**AGENDA**  
**CITY OF CEDAR FALLS, IOWA**  
**PLANNING AND ZONING COMMISSION MEETING**  
**WEDNESDAY, AUGUST 23, 2023**  
**5:30 PM AT CITY HALL, 220 CLAY STREET**

**TO:** Planning and Zoning Commission  
**FROM:** Michelle Pezley, Planner III  
**Matthew Tolan, EI, Civil Engineer II**  
**DATE:** August 23, 2023  
**SUBJECT:** MP23-003: Revision of Arbor's Master Plan

**TO:** Planning and Zoning Commission  
**FROM:** Michelle Pezley, Planner III  
           Matthew Tolan, EI, Civil Engineer II  
**DATE:** August 23, 2023  
**SUBJECT:** Revision to the preliminary plat for The Arbors subdivision

# PLAN A

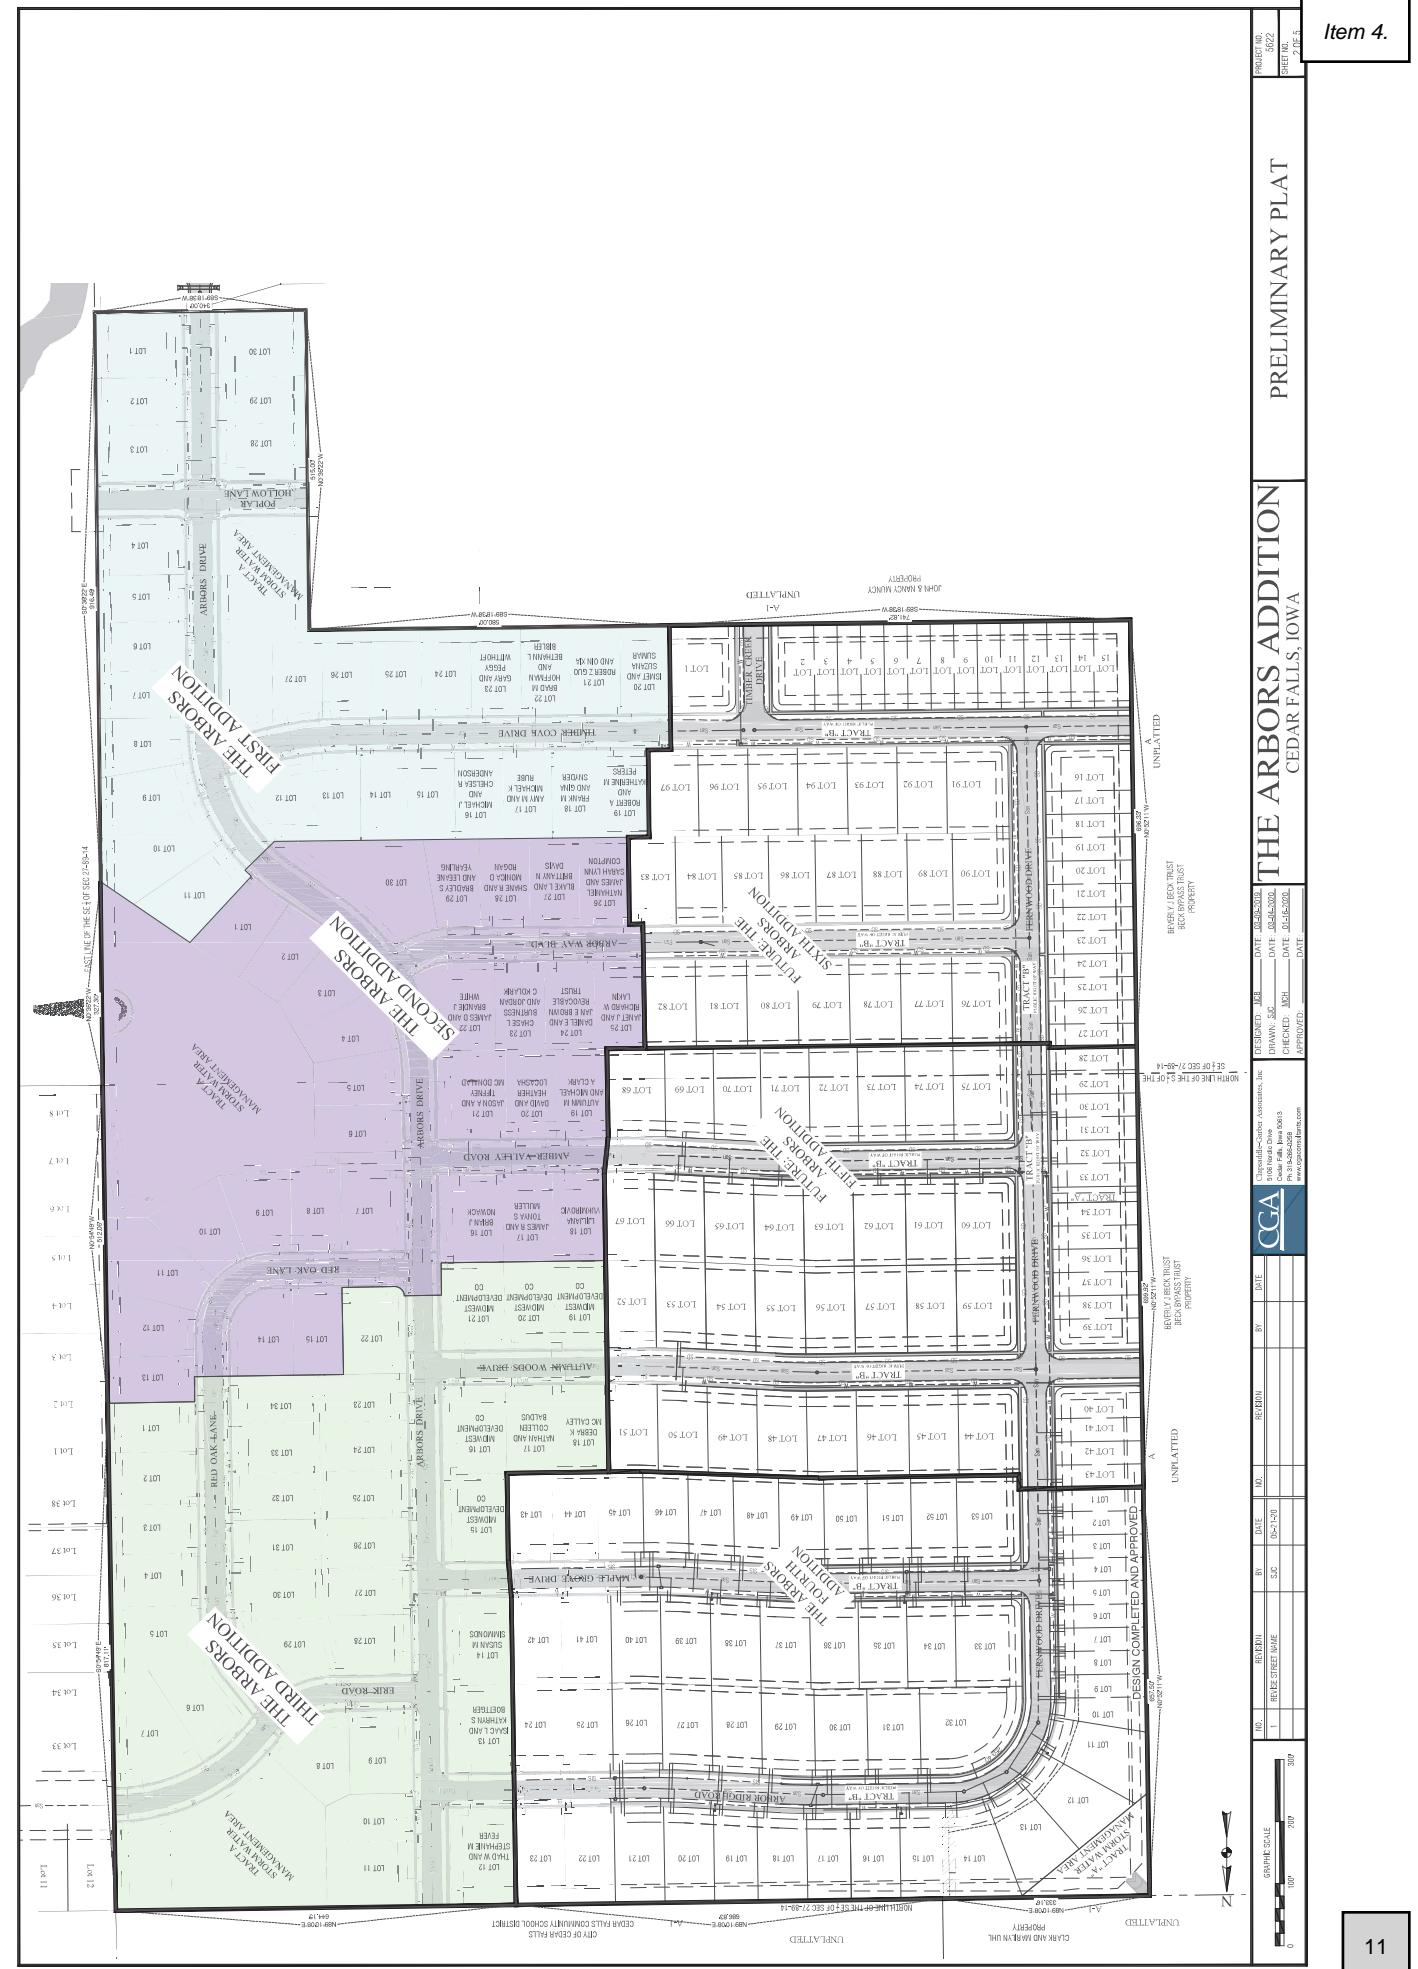
To accommodate any future changes to the type of lots (single family vs. bi-attached), the applicant is requesting approval of two different options for their master plan: Plan A shows the master plan as approved in May of 2020 including the bi-attached units in Phase 5 (see attached) and Plan B, which shows the master plan that converts 10 bi-attached lots to 5 single family detached lots and illustrates the minor change to the phasing (see attached). If both are approved, the applicant will not need to change the master plan again if they decide to go back to the bi-attached units. Staff notes that the preliminary plat will need to be conforming to the master plan, and the final plat will need to be in conformance of the preliminary plat.

# PLAN B

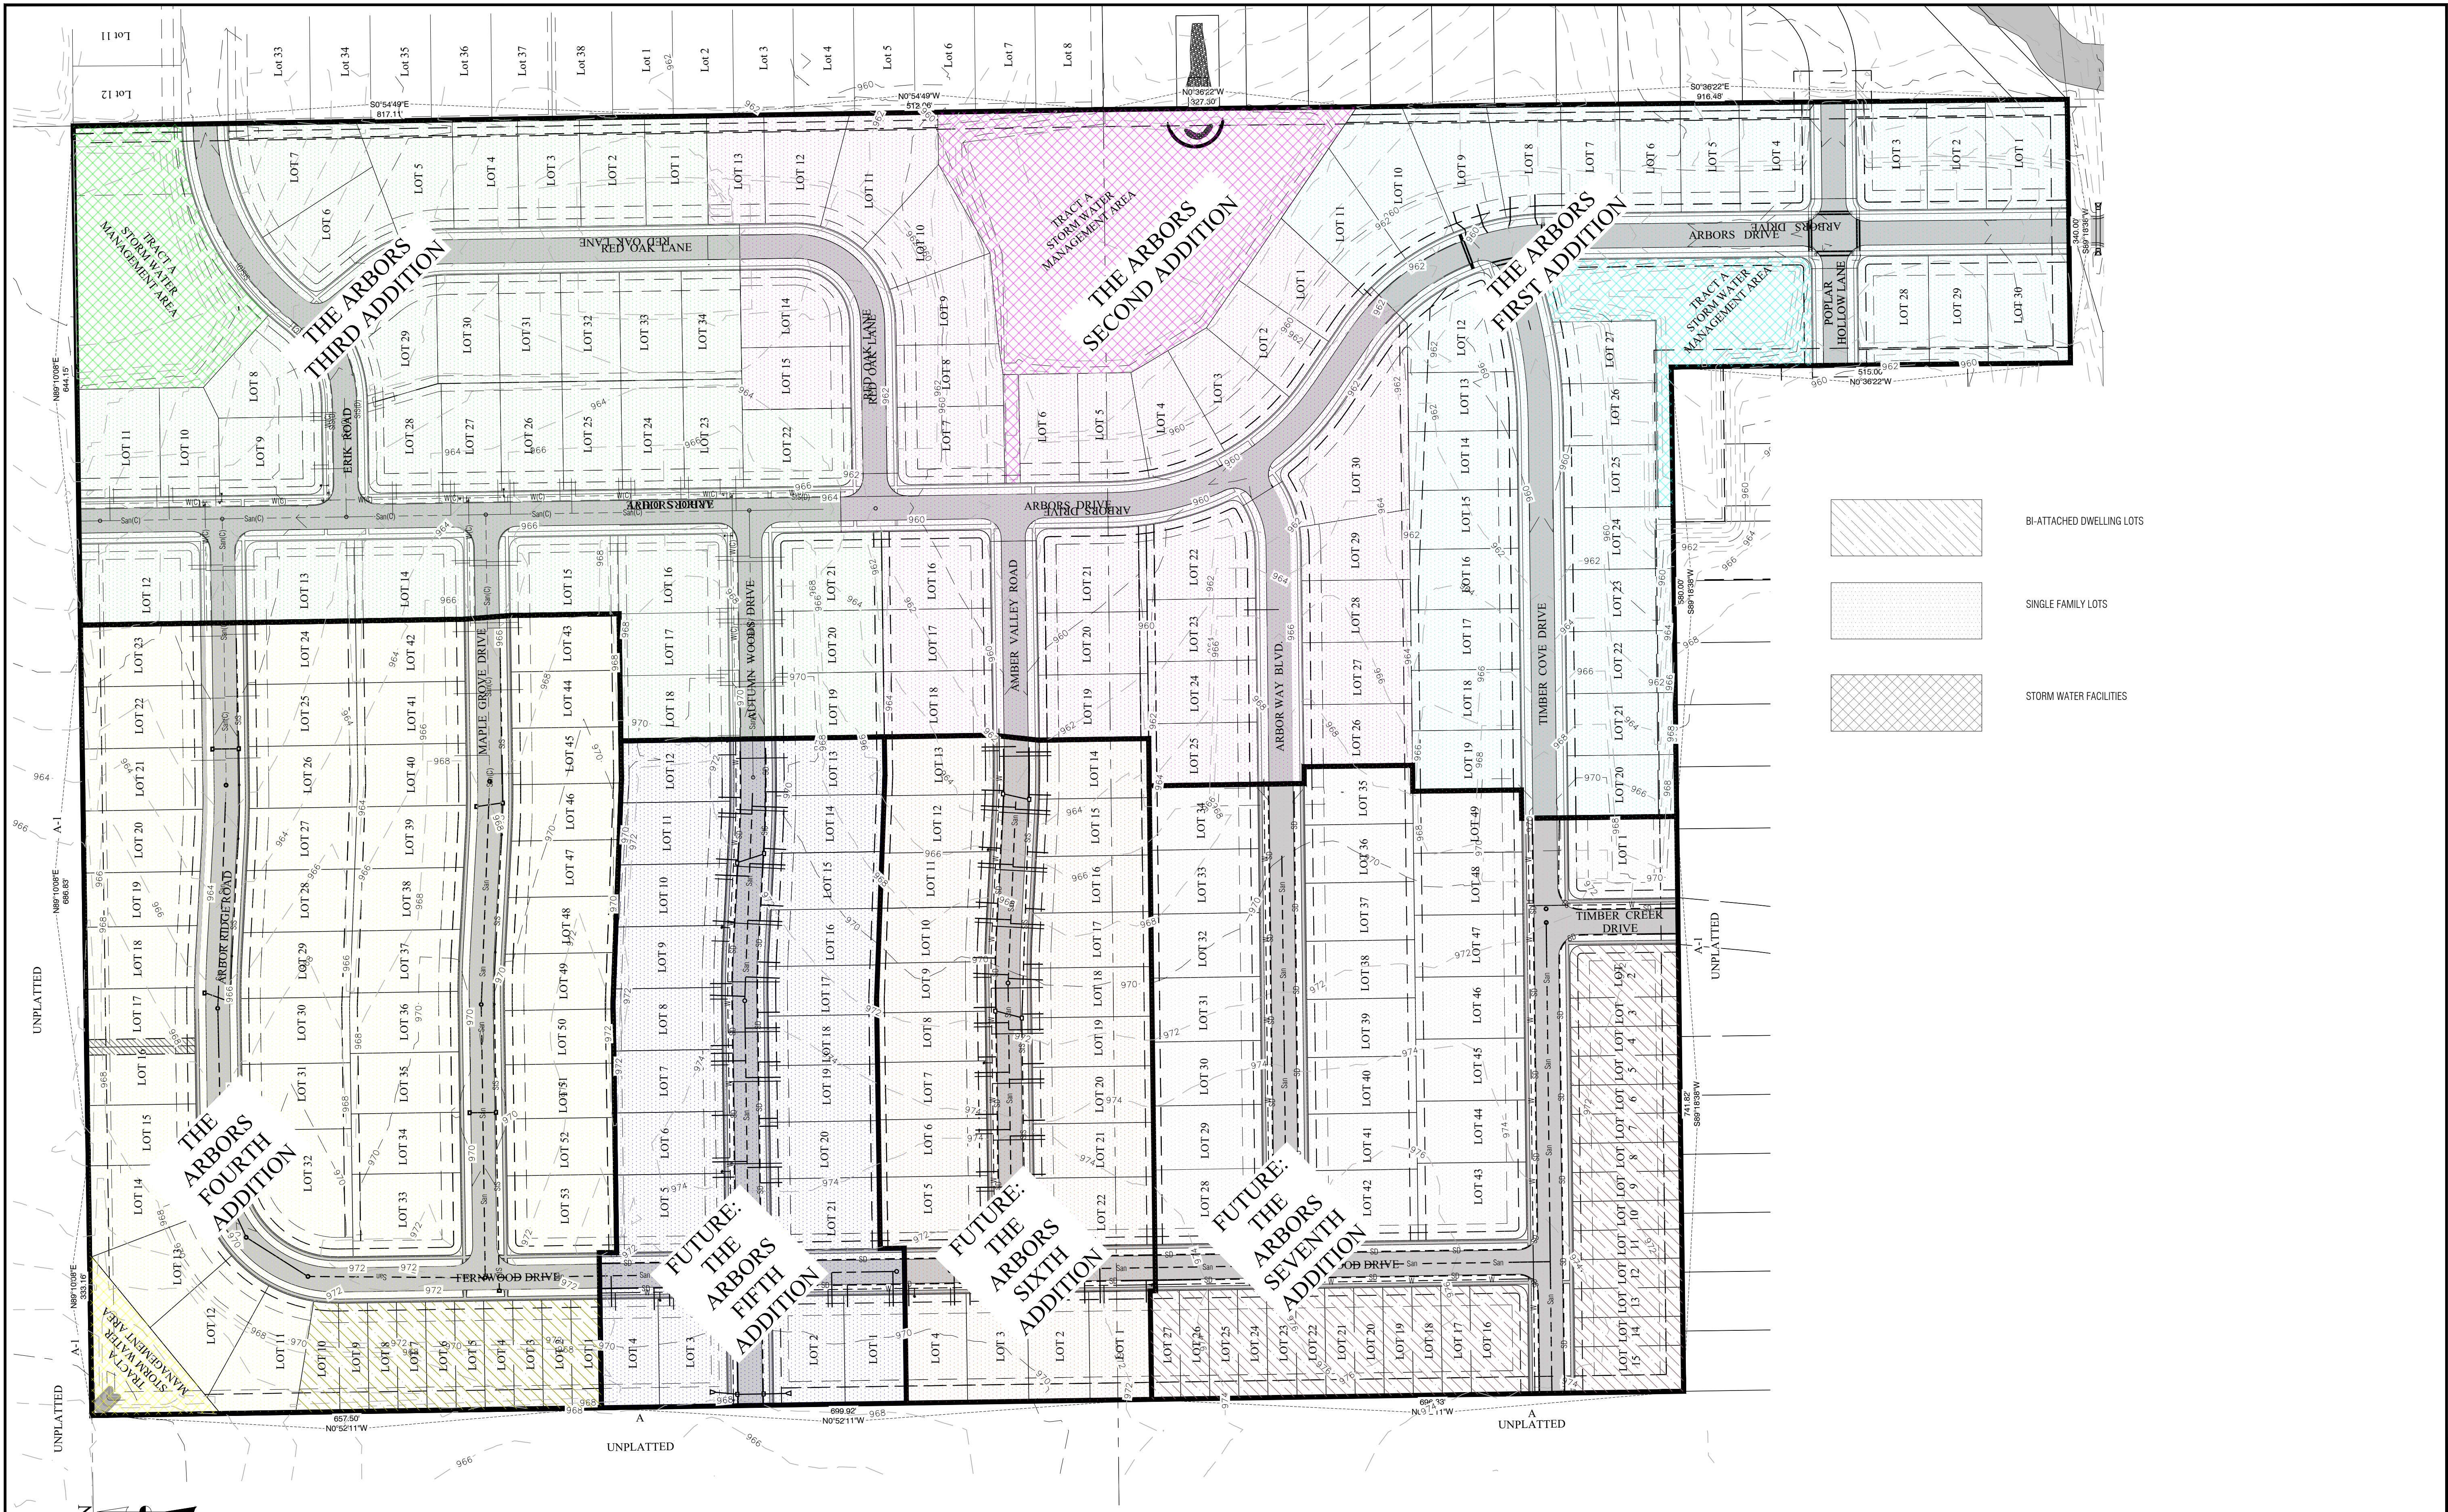
The applicant now requests to remove the bi-attached lots in the preliminary plat for the original Phase 5, which reduces the number of residential lots by 5 units. They are also requesting to change phase five into two phases, for a total of 7 phases as shown in Plan B (attached). The following table shows the revised number of lots proposed:

The master plan for pedestrian traffic, locations of streets and sidewalks have not changed with this amendment. The master plan, Plan B will reduce the number of driveways and access points to Fernwood Drive, by removing the bi-attached lots. However, in the future, if someone wants to add a bi-attached unit in revised Phase 5 or 6, they will not need to revise the master plan to have the additional unit approved.

The applicant proposes to divide the original Phase 5 into two phases as indicated above. The additional phase will not change the pattern of development, which extends from north to south, rather it just reduces the number of lots per phase.

Cedar Falls Utilities (CFU) has reviewed the revised Master Plan for The Arbors subdivision and has no objections.

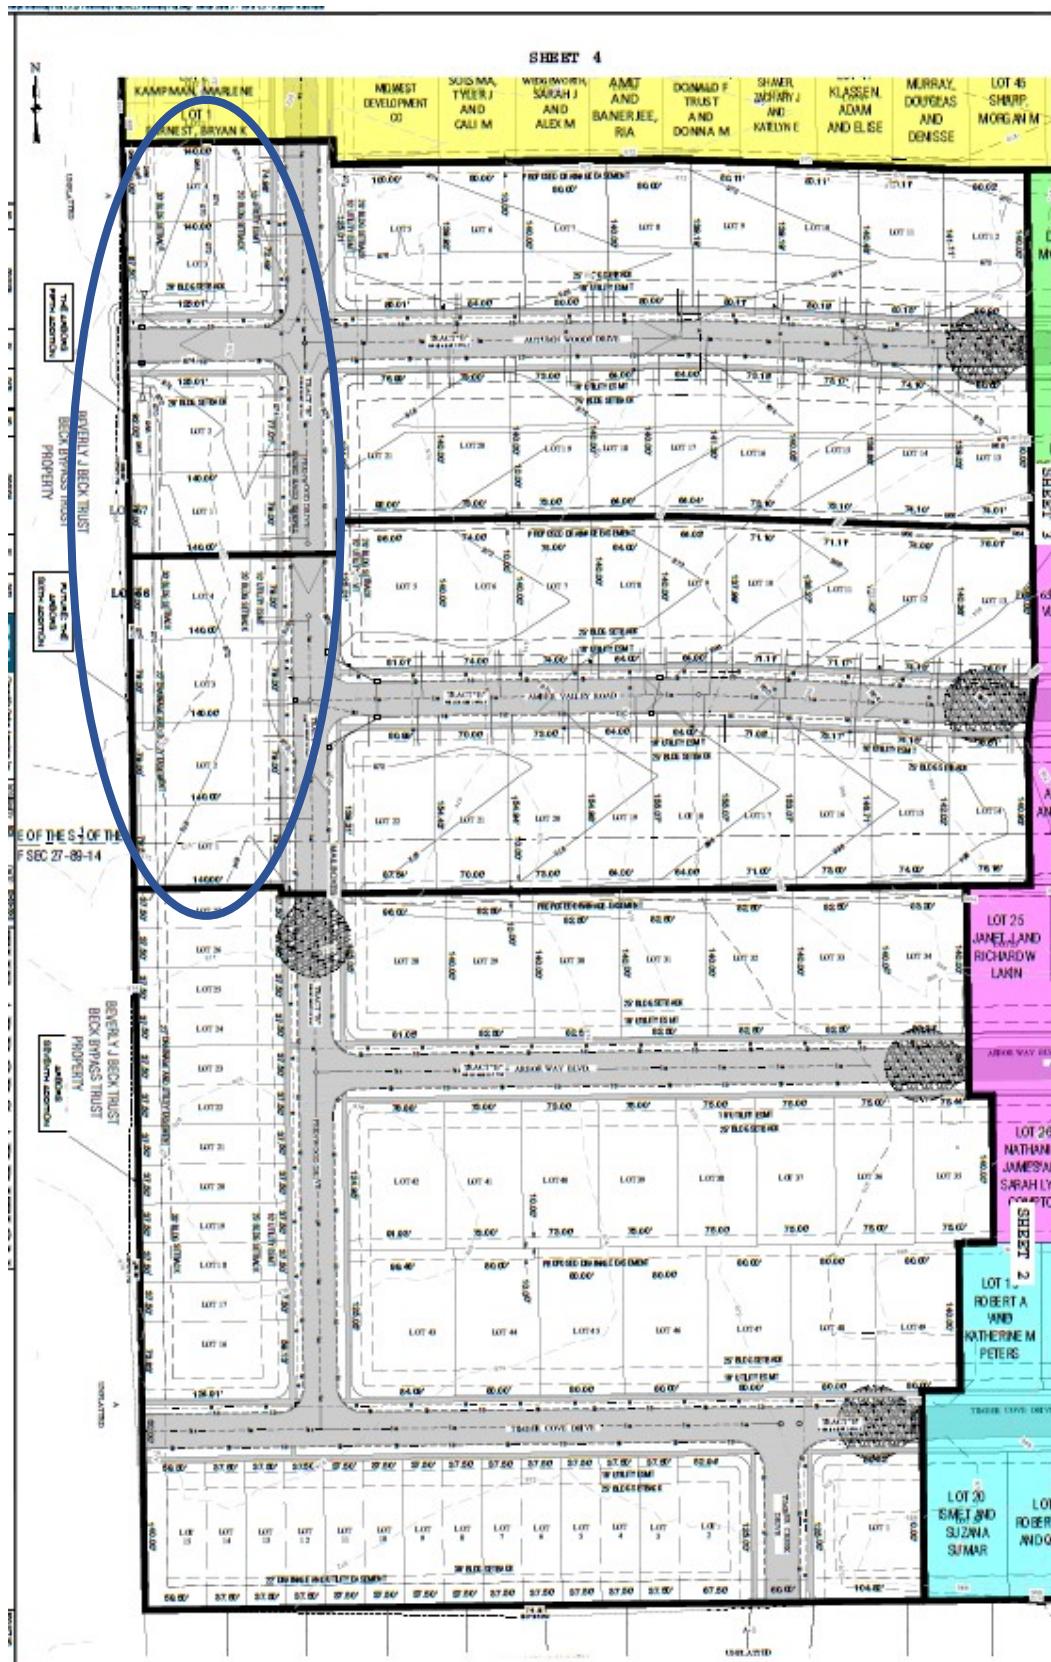
With this revision, the applicant proposes 21 lots intended for single family detached dwellings for Phase 5, 22 lots intended for single family detached dwellings for Phase 6, and 49 lots for a mix of single-family detached dwellings and single family bi-attached dwellings for Phase 7. Phase 7 will still have the 26 bi-attached lots. As shown on the next page, highlighted in blue are the lots that are converted from single family bi-attached lots into single-family detached lots.

The updated residential lots are proposed to be between 10,000 square feet to 12,000 square feet. The revised lots also are at least 70 feet wide. Within the RP Zoning District, there is flexibility to establish unique building setbacks for the lots. In The Arbors subdivision, the developer has specified 5-foot side yard setbacks, 30-foot rear yard setbacks, and 25-foot front yard setbacks. On lots that have a street-fronting side yard, the setback is 20 feet. The R-4 District setback standards apply around the perimeter of any RP District. Therefore, developer has established a 30-foot setback around the perimeter of the RP District, so lots that abut the western boundary of the district have 30-foot setbacks.
